METROPOLITAN GOVERNMENT OF NASHVILLE AND DAVIDSON COUNTY

STAFF RECOMMENDATION
3514 Central Avenue
May 15, 2013

Application: Partial Demolition; New Construction—Addition; Setback Reduction
District: Richland-West End Neighborhood Conservation Zoning Overlay
Council District: 24
Map and Parcel Number: 10405032700
Applicant: Greg Davis, MCR Group
Project Lead: Sean Alexander, sean.alexander@nashville.gov

1931-1951 Sanborn Map

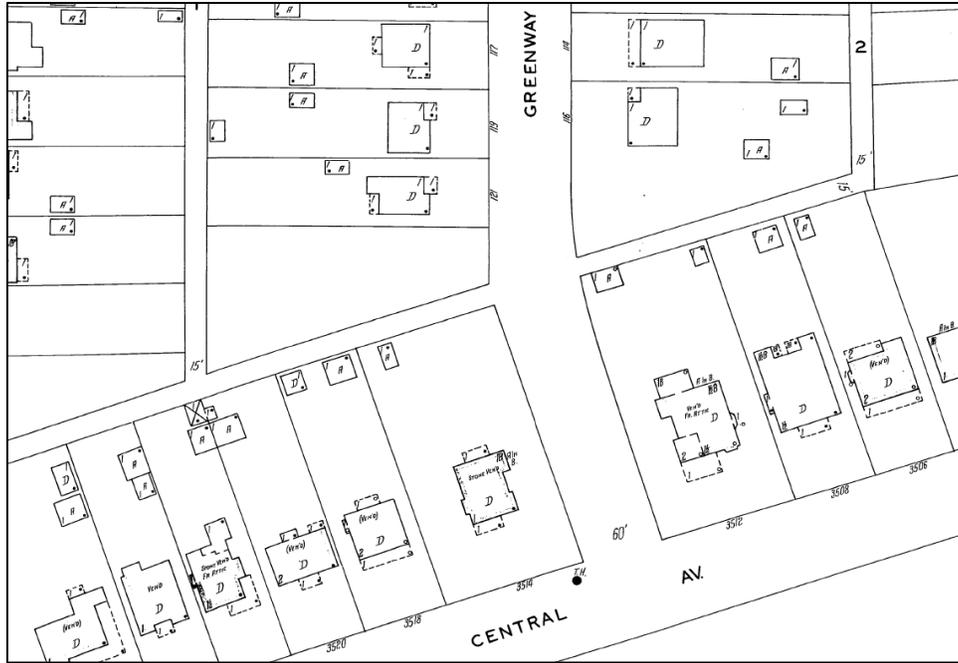
The existing rear addition was originally an open porch, as shown on the 1931-1951 Sanborn Map. In enclosing the porch, its historic integrity has been substantially diminished. Although it would be visible from the side street, it is not visible from Central Avenue. For these reasons, staff finds that the existing rear addition is not a significant feature of the house, and that its demolition would meet guideline III.B.2.b.

3514 Central, existing rear addition and deck to be demolished.

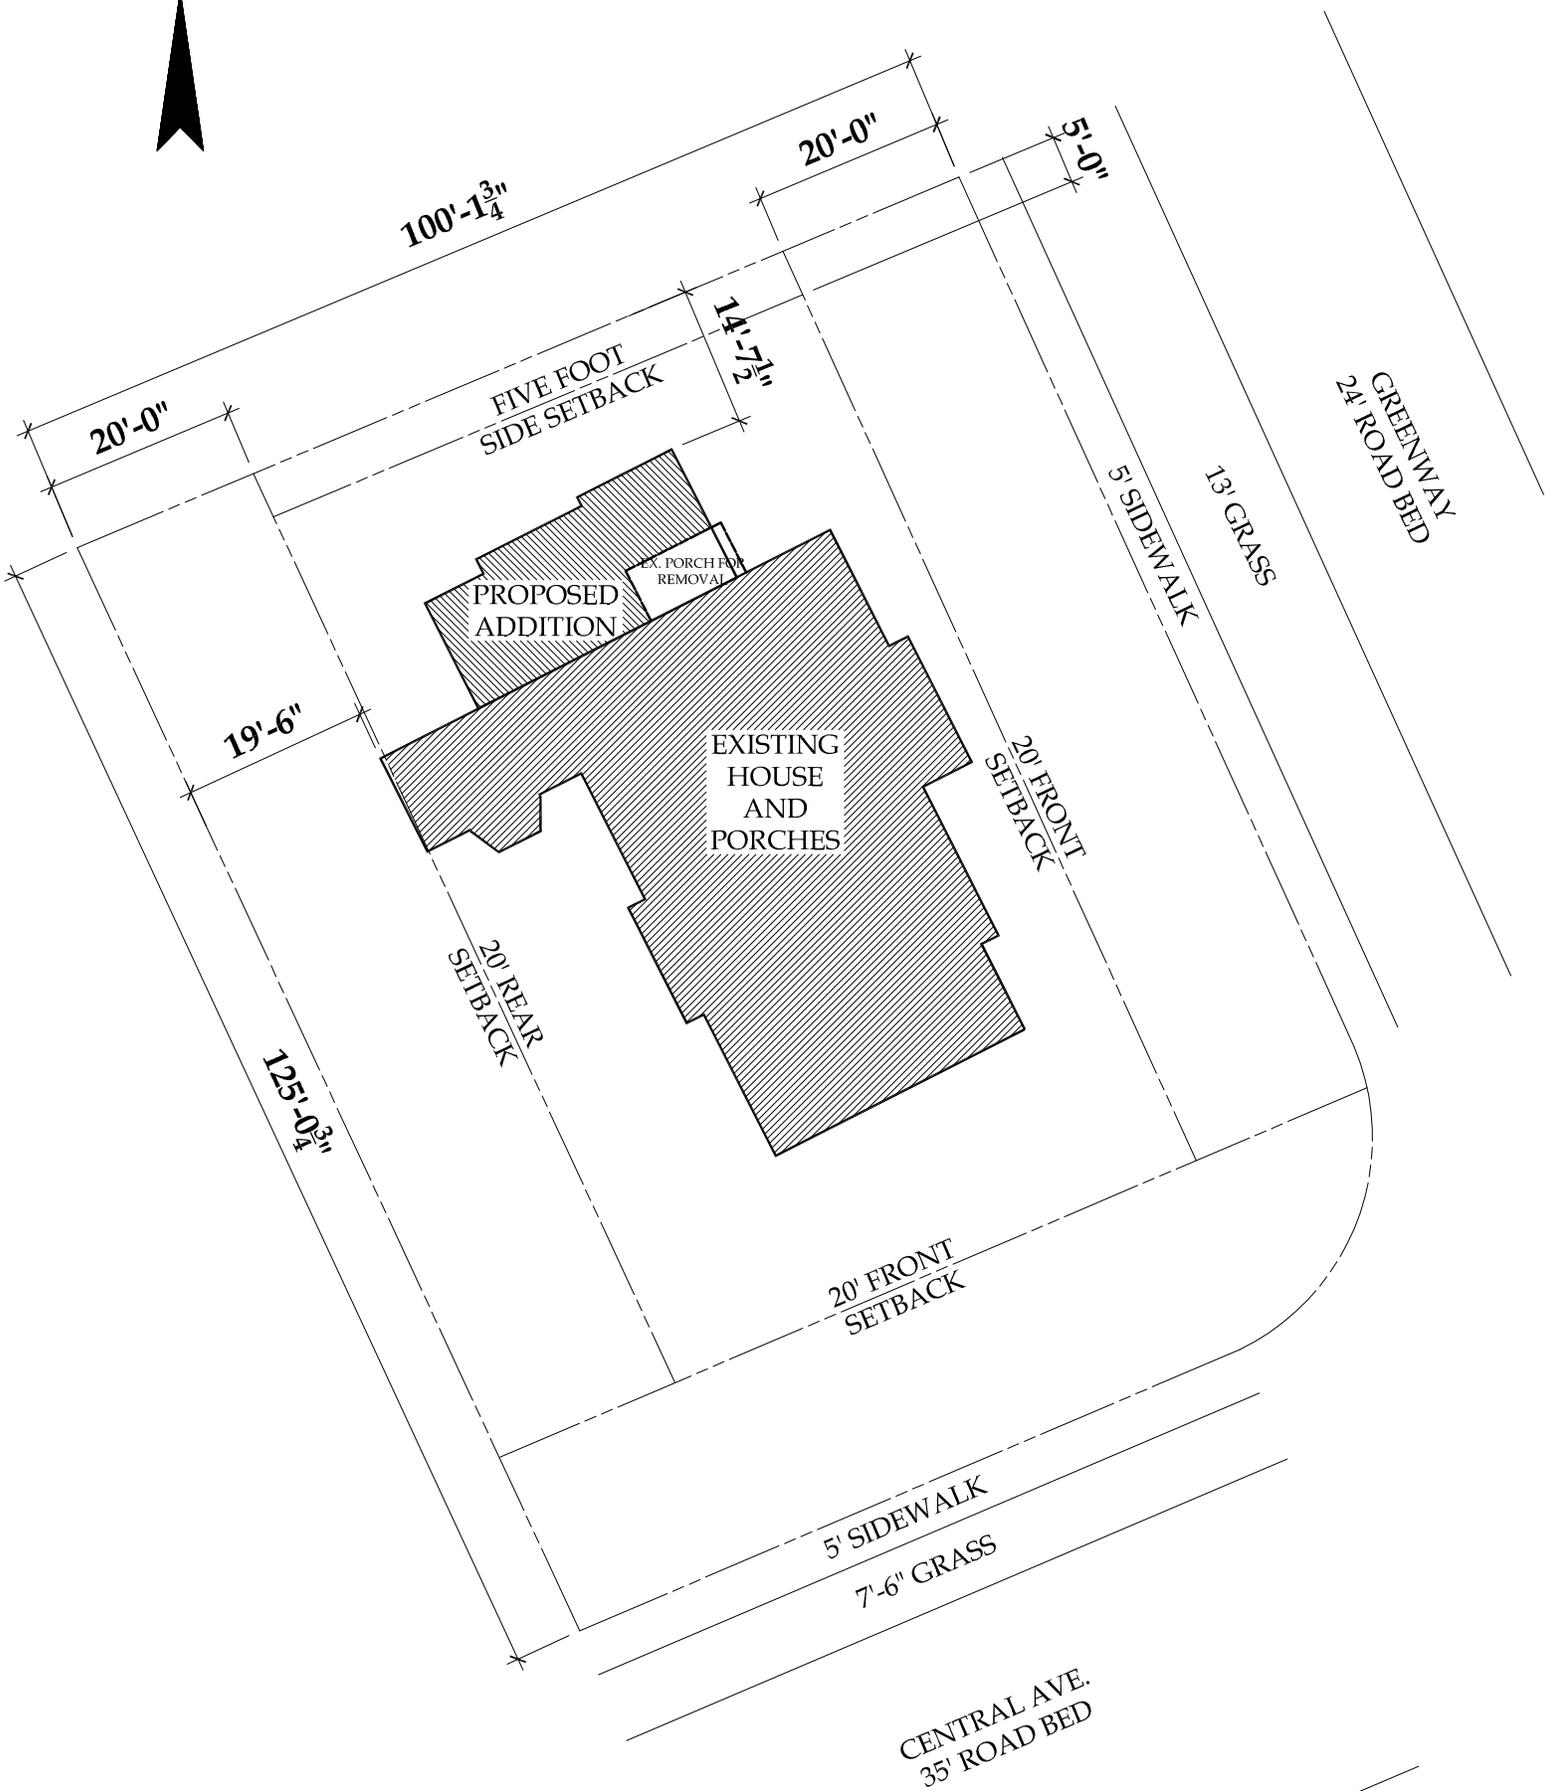
Analysis and Findings: The applicant is proposing to demolish an existing rear addition and construct a new rear addition.

EAST ELEVATION
 $\frac{1}{8}'' = 1' - 0''$

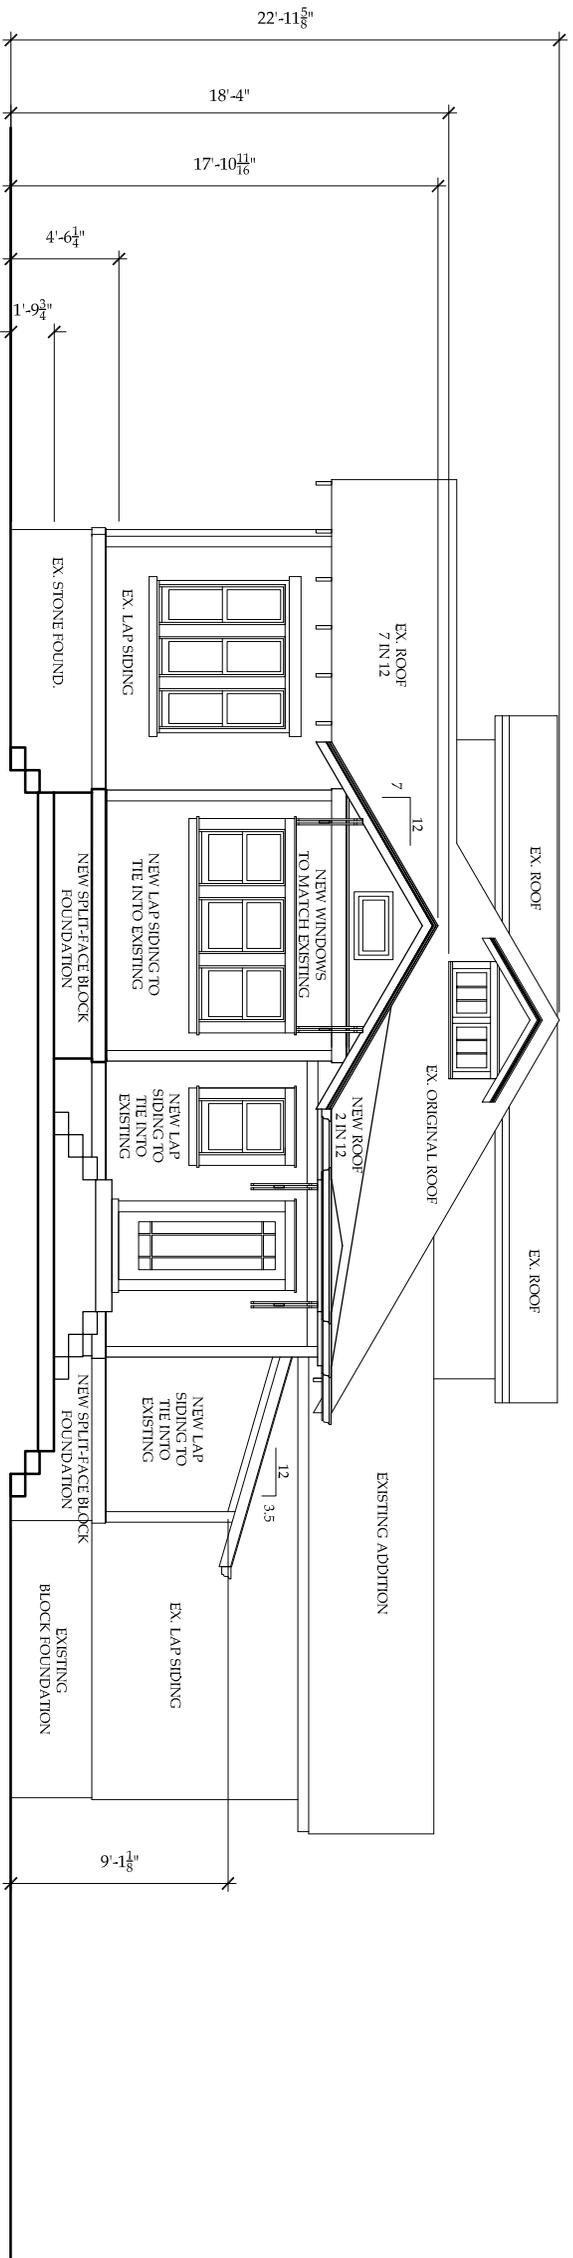
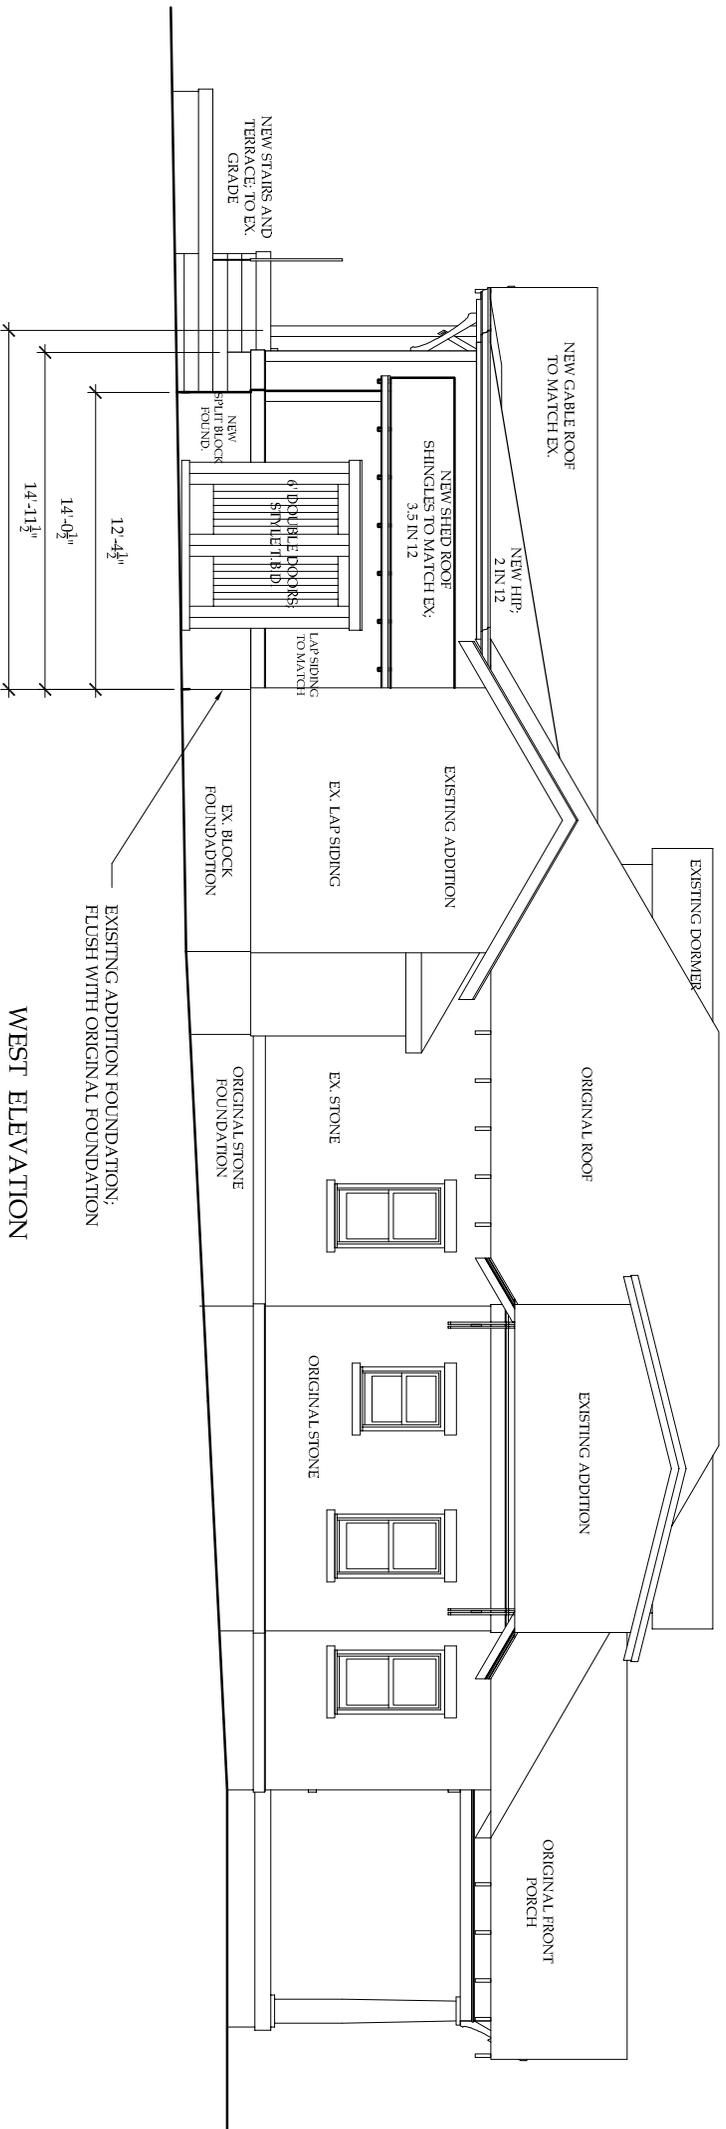
The new rear addition will sit in from the sides of the house by eleven feet (11') on each side, obscured on the left by the earlier side addition. The roof of the addition will sit five feet (5') below the primary roof of the house and one foot (1') below the ridges of existing side facing gables. In this manner the addition will be completely contained within the "silhouette" of the house, entirely obscured from view on Central Avenue.

The new addition will extend fifteen feet (15') beyond the rear wall of the house toward the rear of the property. Because the lot was truncated by the 1961 subdivision, this will require a reduction of the rear setback from twenty feet (20') to fourteen feet (14'). Staff

The exterior materials of the addition will include a split-faced concrete block foundation, cement-fiber clapboard siding, and a composite shingle roof. The trim and material of the windows is not known. Staff finds the materials to meet guideline II.B.1.d., with the unknown materials to be approved administratively before issuing a permit.

The roofs of the new addition will be: a rear-facing gable with a 7:12 pitch, and 2:12 pitched partial hip at the far left-rear. This low pitched roof will be obscured by the gable of the rear and existing side gable additions. These roofs are compatible with those of the house and meet guideline II.B.1.e.

The rear and right side walls of the addition will continue the window pattern of the existing house with regularly spaced, vertically oriented windows. Staff finds the addition will meet guideline II.B.1.g.

Recommendation: Staff recommends approval of the application to demolish the existing rear addition and construct a new rear addition with a reduced rear setback, with a condition that the unknown materials are approved administratively, finding the application to meet the design guidelines for additions in the Richland-West End Neighborhood Conservation Zoning Overlay.
